SUNSHINE COAST REGIONAL DISTRICT

Question and Answers # 2

Refrigeration System Reconstruction – Condenser Replacement

2561312

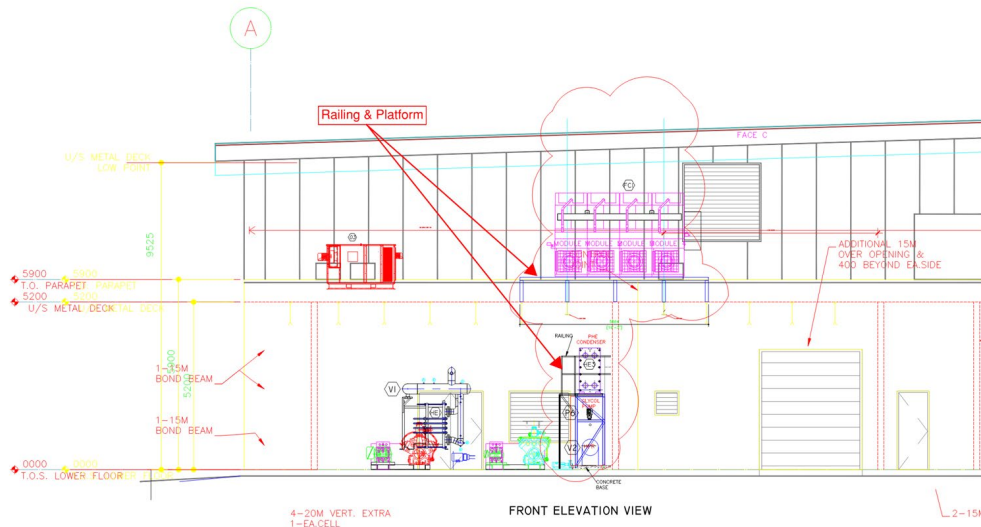
Question: Could you please clarify the manufacturer and specifications for the Warm Brine Balance Tank (tag ET-3) shown in the schematic?

Answer: We believe you are discussing tank V4 which is from 2006 and there is no existing information on this tank. The site does not have an ET-3 tank that we are aware of.
